New Barnsbury, The Barnsbury Estate

Design & Access Statement - Addendum
Block D1 and D2 Top Floor Amendments

February 2023

Proposed level 108 plan

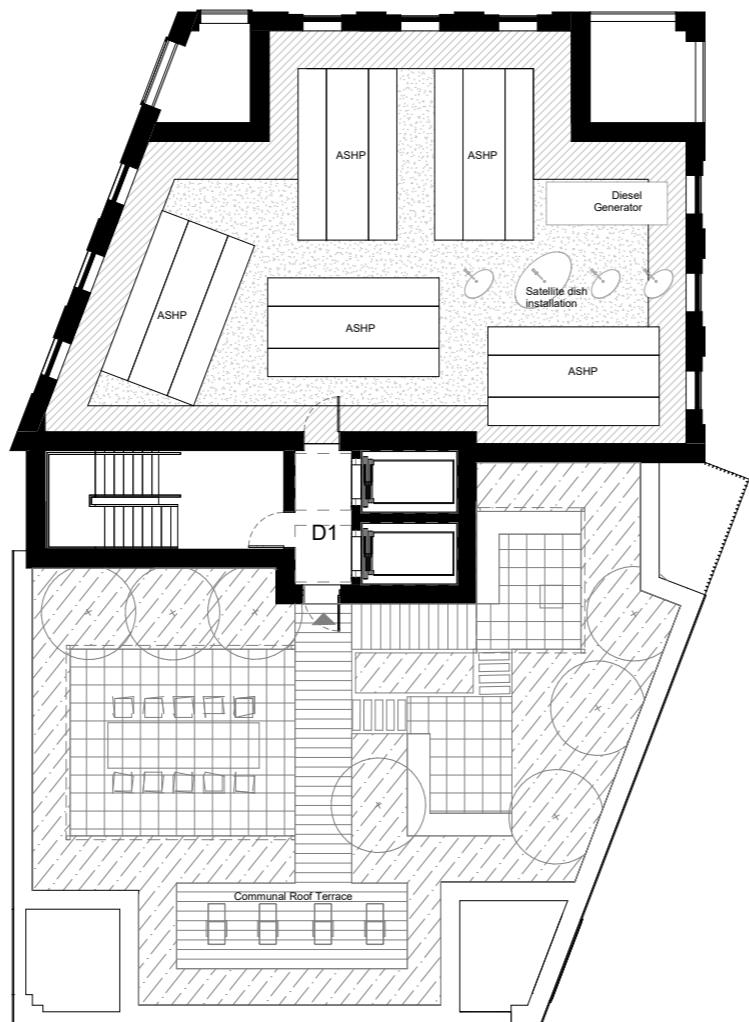
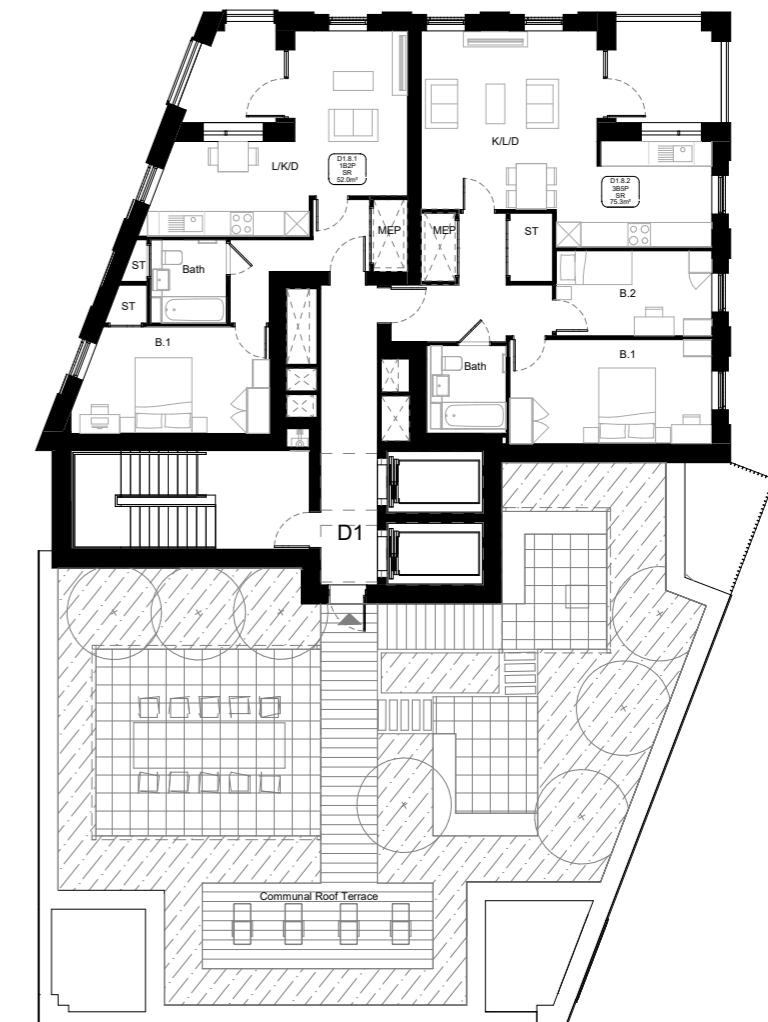
The rooftop plant at level 108 of Block D1 will be relocated to D2. This move allows residential accommodation to take its place, effectively replacing the two homes from D2.

Due to the smaller building footprint of D1 the unit mix changes slightly.

Block D1 (affordable tenure) gains two homes:

1 x 1B-2P

1 x 2B-3P

The addition of these two homes results in an increased demand in cycle and refuse storage, however the previous scheme provided surplus capacity and therefore the stores at ground floor do not change.

Proposed level 110 plan

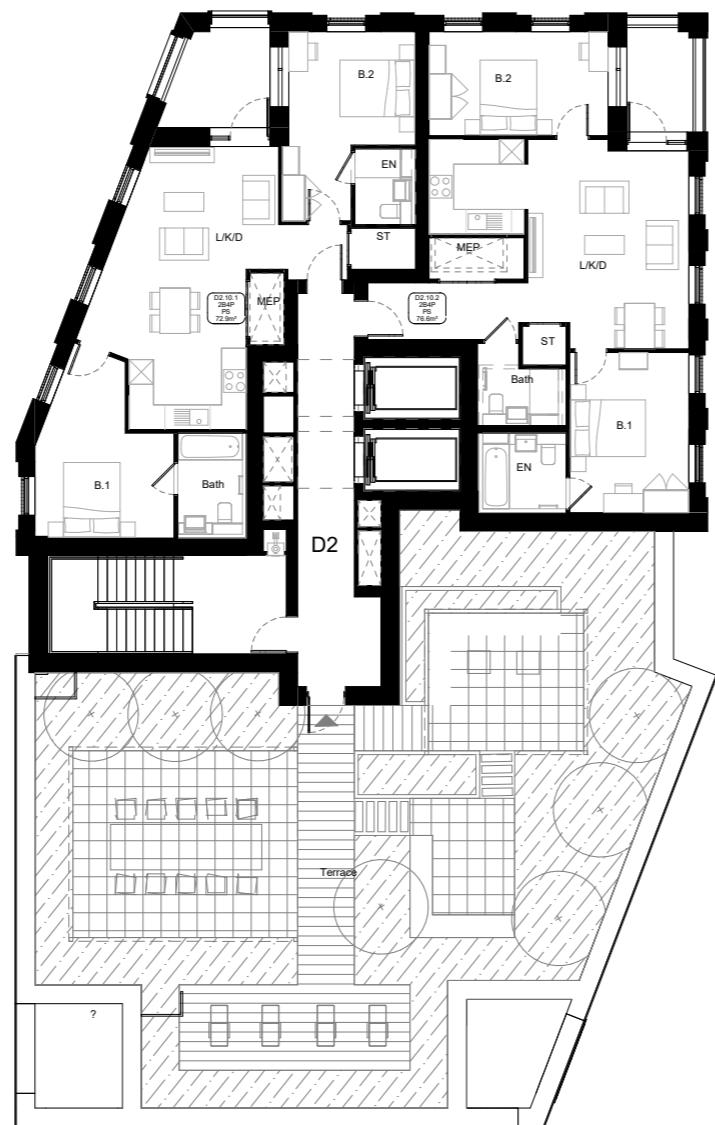
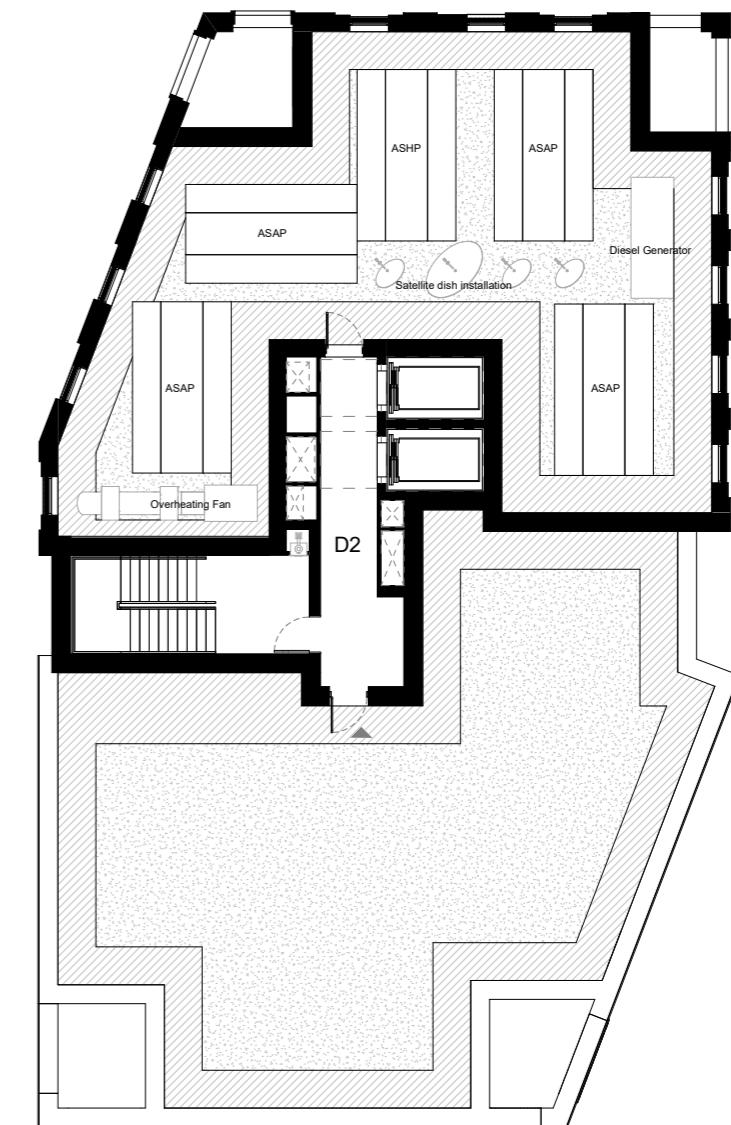
Level 110 of Block D2 has an FFL of +31.65m and is the only floor that sits above 30m.

To remove habitable space above this threshold the plant from D1 has been relocated to this floor, removing two homes from Block D2 (private tenure):

2 x 2B-4P

The plant remains set within the facade to be concealed from view while providing free air movement to ASHP. The number, size and capacity of ASHP and rooftop PV does not change, and is replaced like-for-like across the two blocks.

The communal roof terrace has been removed from D2 to ensure no habitable space either internally or externally is provided above +30m FFL. This area of roof will be replaced with bio-diverse green roof. Refer to the landscape addendum by Farrer Huxley for more information.

Private & 24 Hour Accessible Space

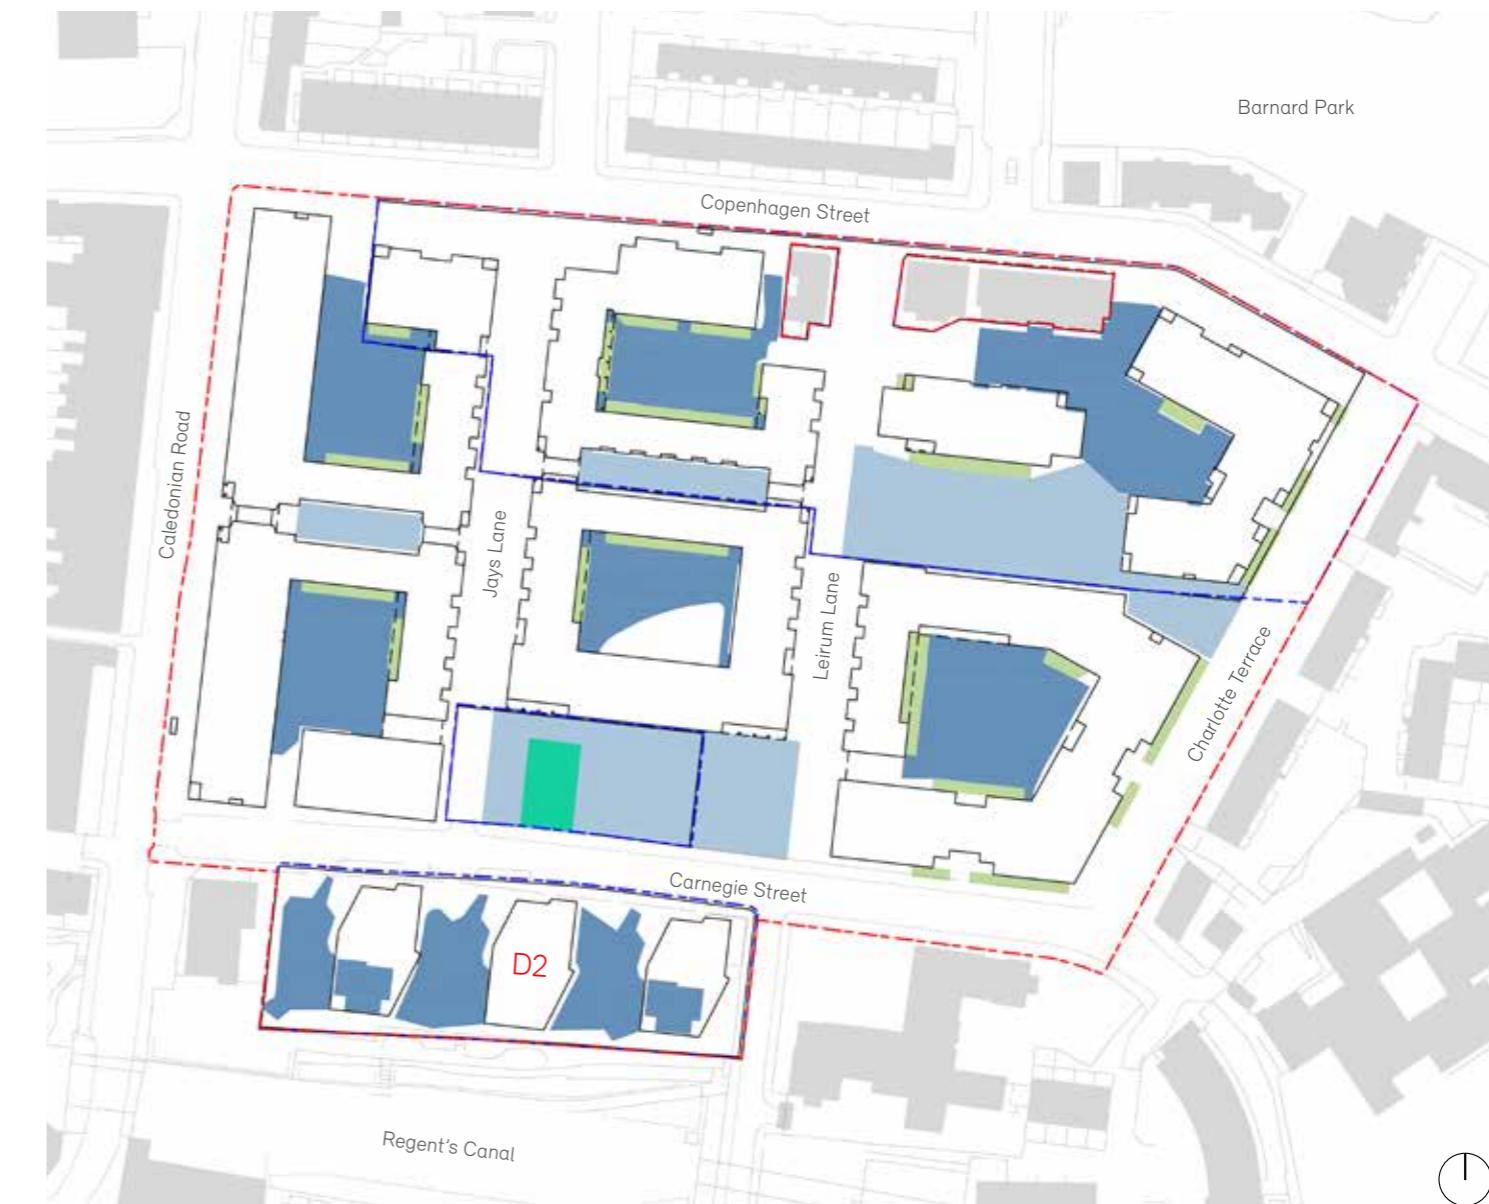
The only amendment to the design and provision of Private and 24 Hour Accessible Space is that the 'resident only' space at the top of D2 has been removed. This is to ensure no habitable space above 30m.

Privacy Zones

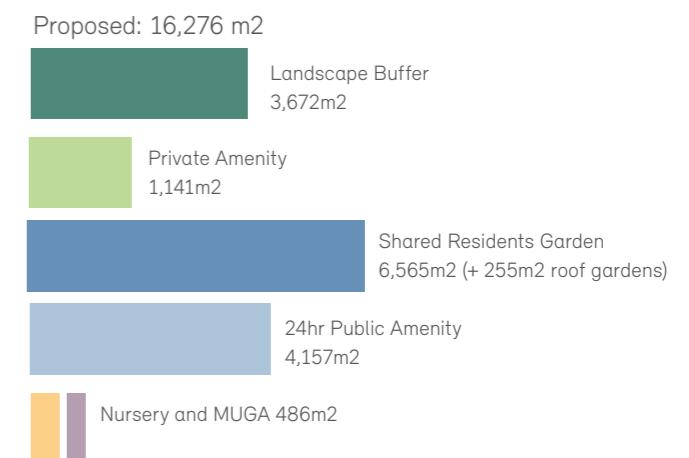
The only amendment to the privacy zone is the removal of the resident only rooftop area in block D2 and the removal of the Buffer and Timber slat fence on the roof.

3.4 Proposed Open Space

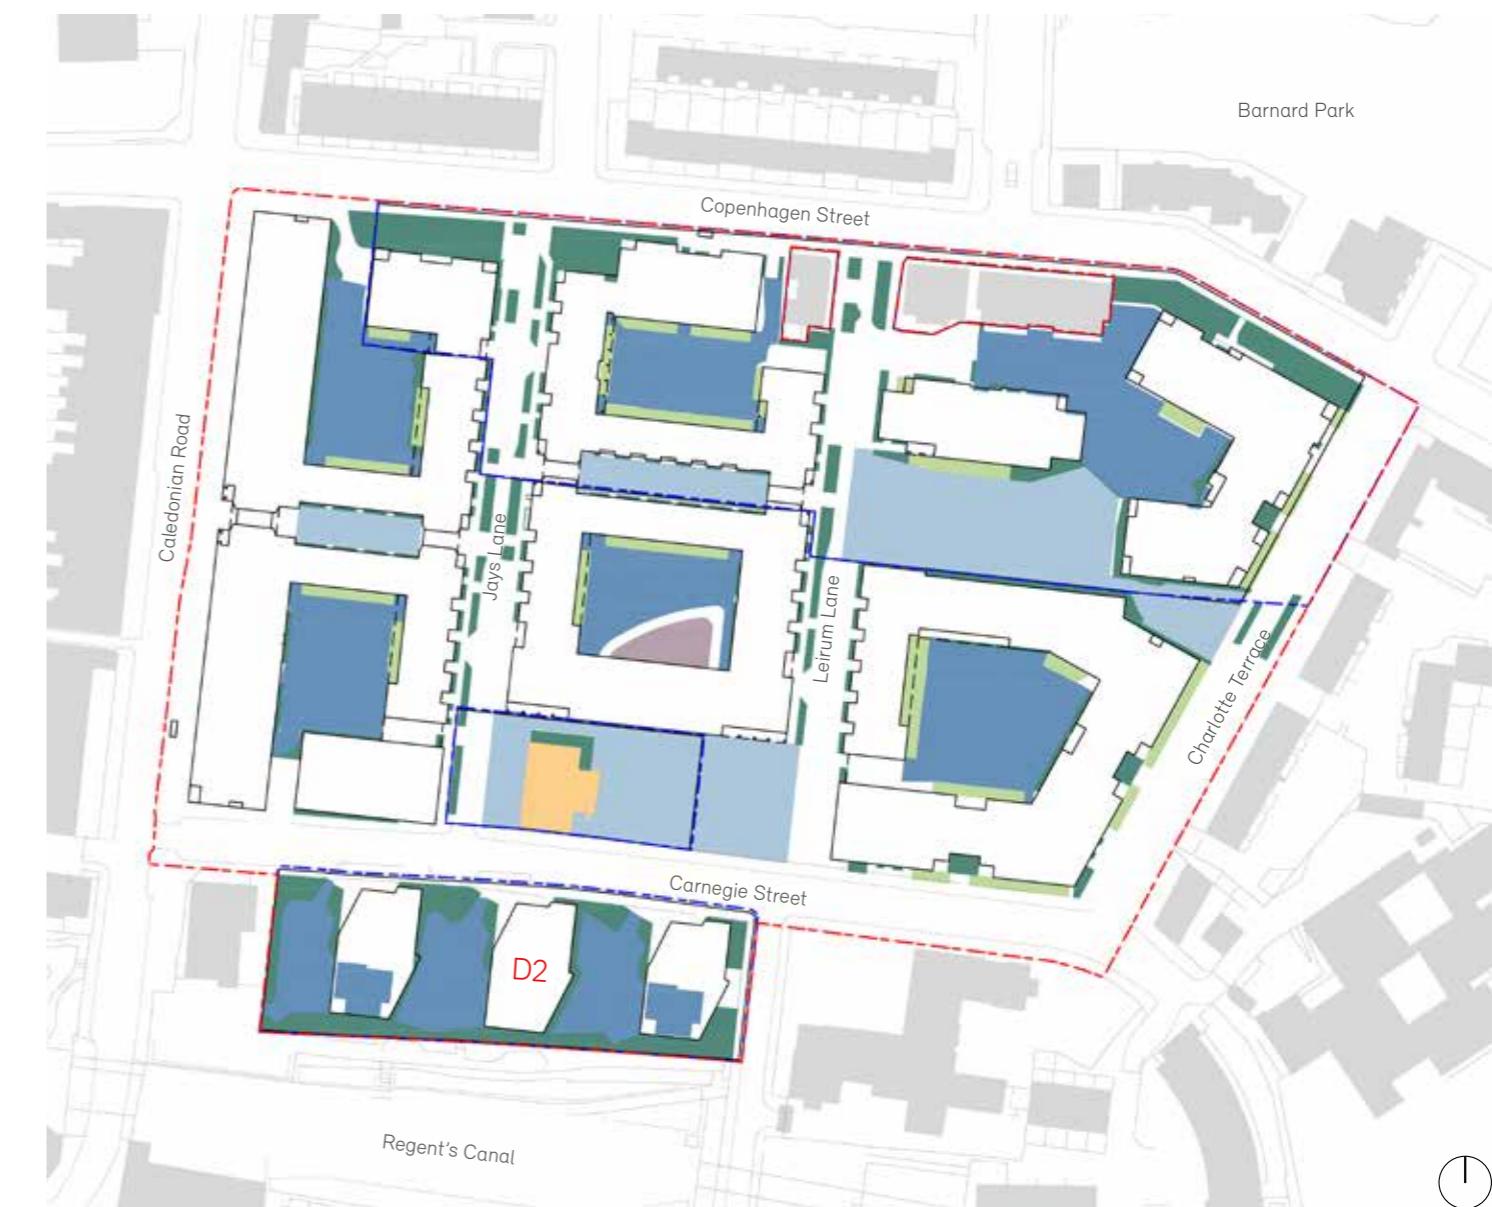
The only amendment to the Proposed Open Space is the removal of the roof terrace on Block D2. This reduces open space by 126 sqm.

3.6 Proposed UGF: Previous Design

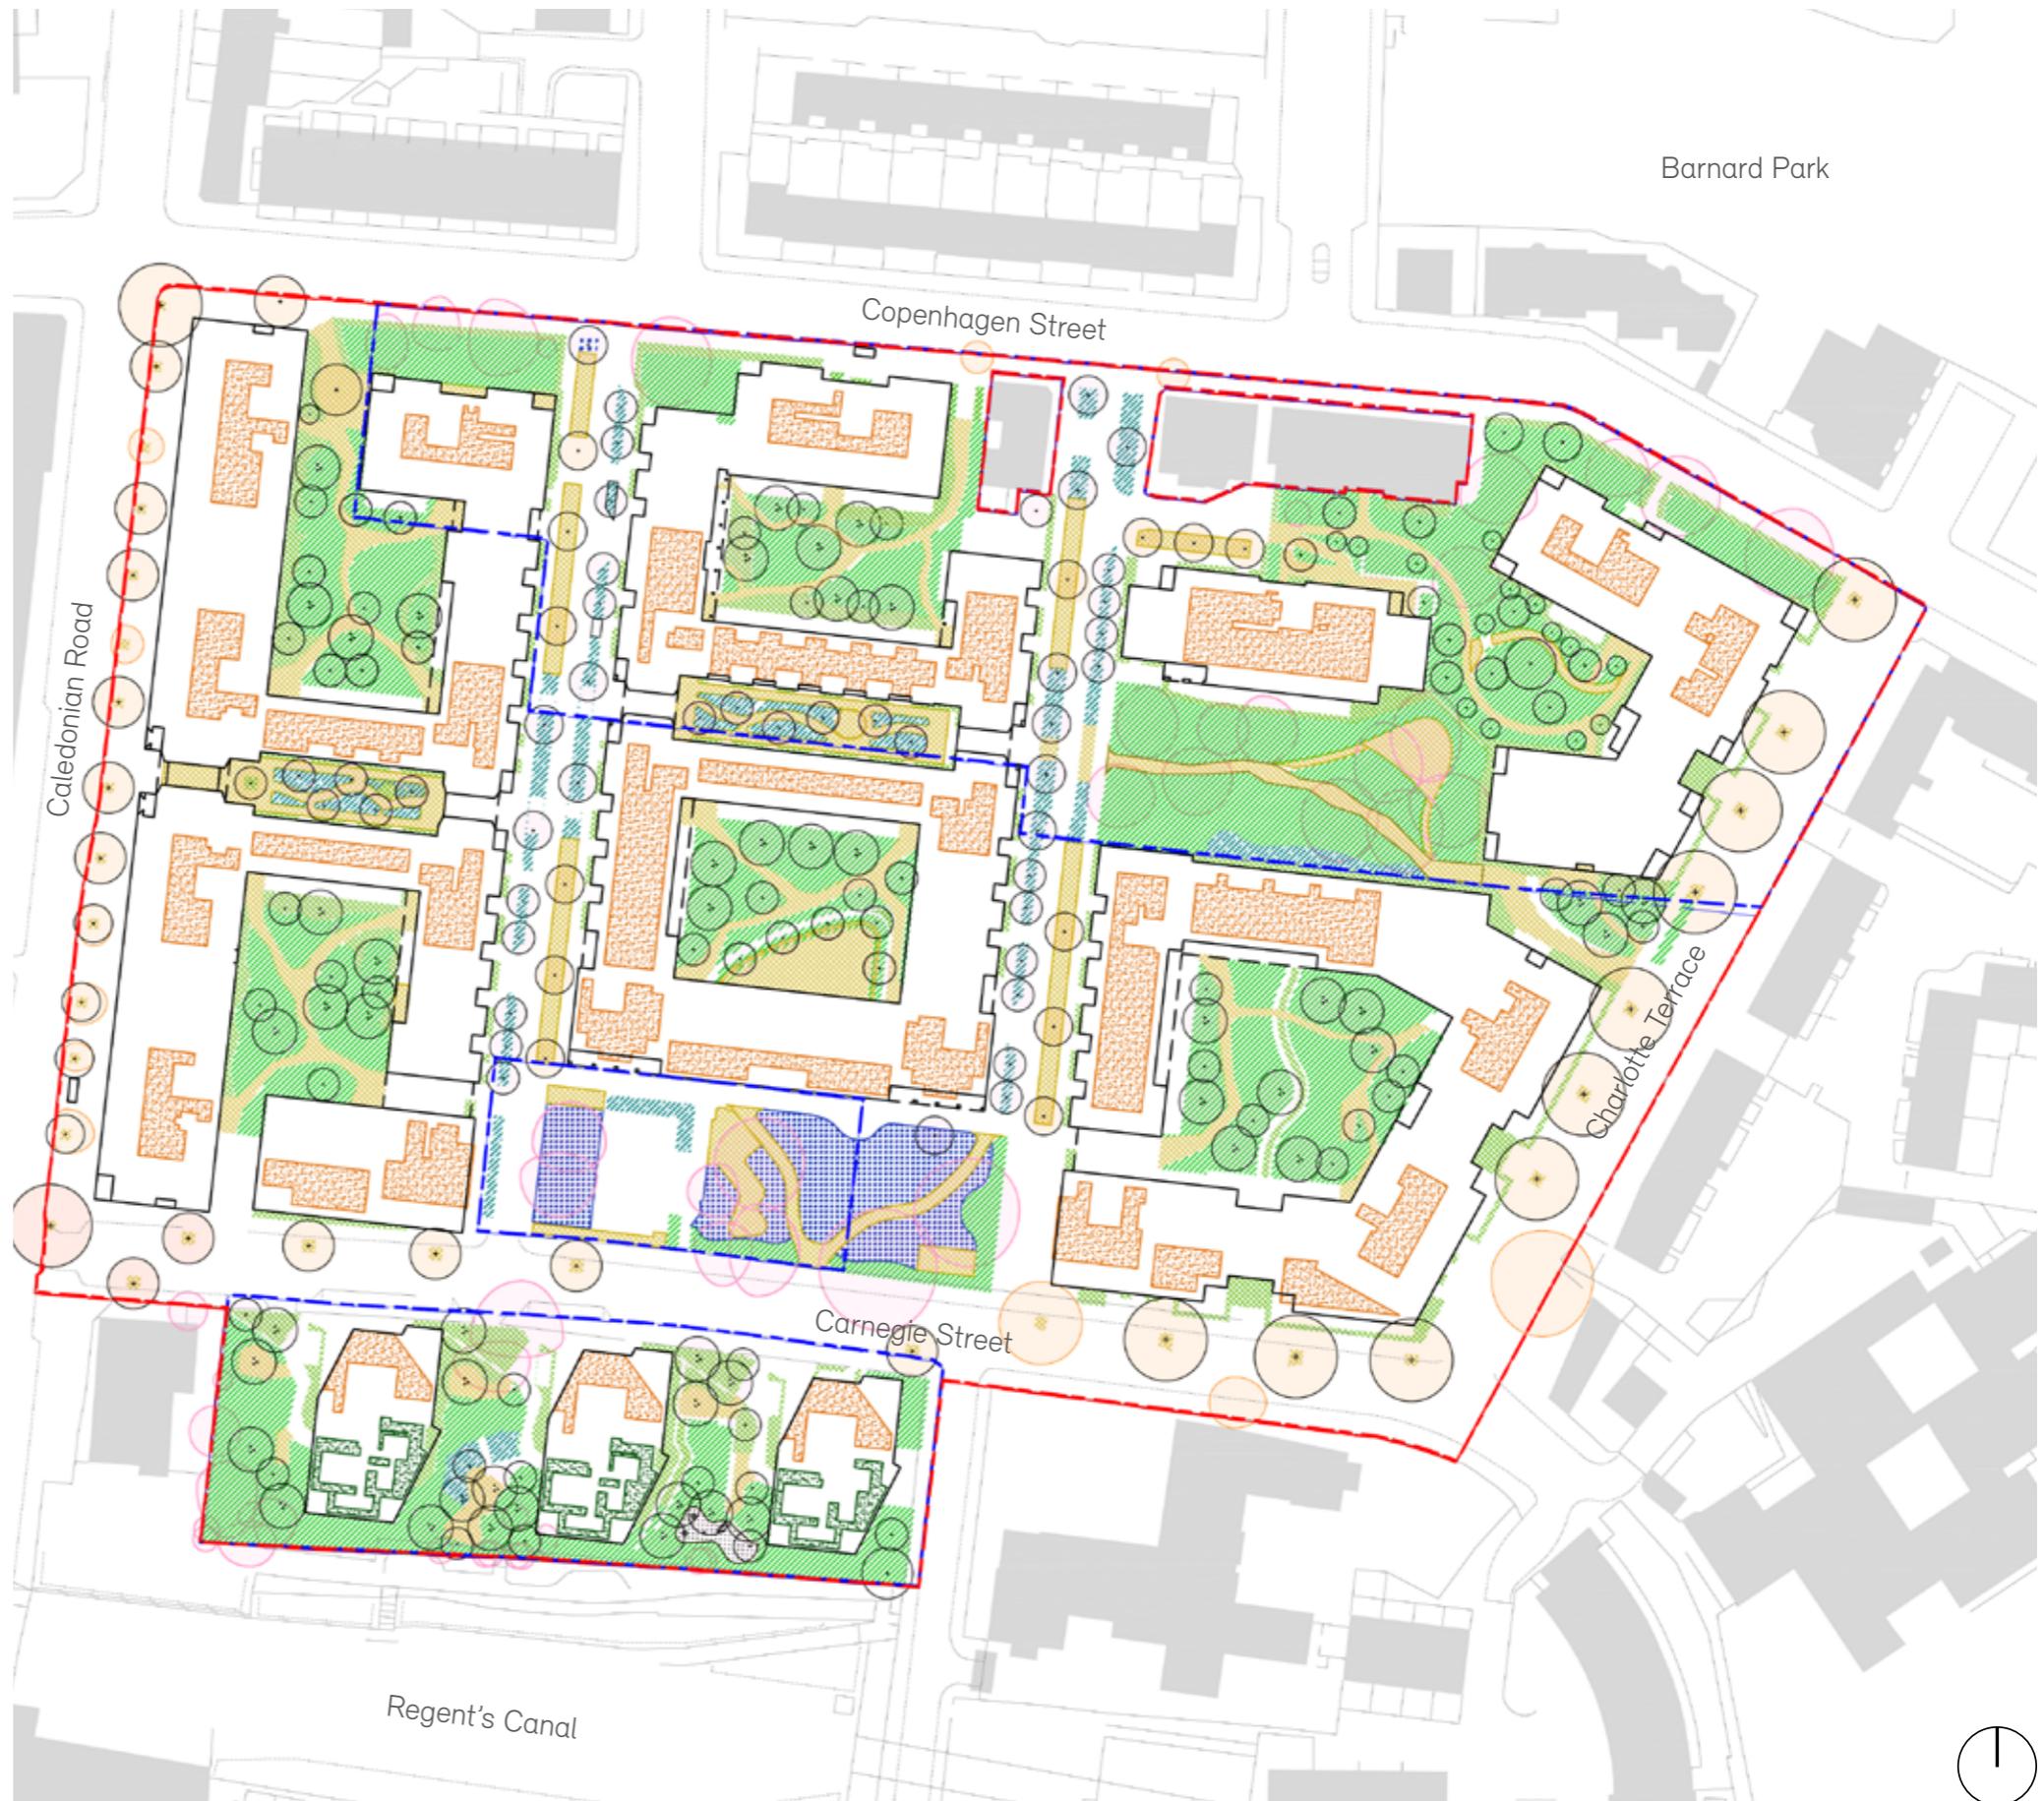
The previous UGF is 0.45.
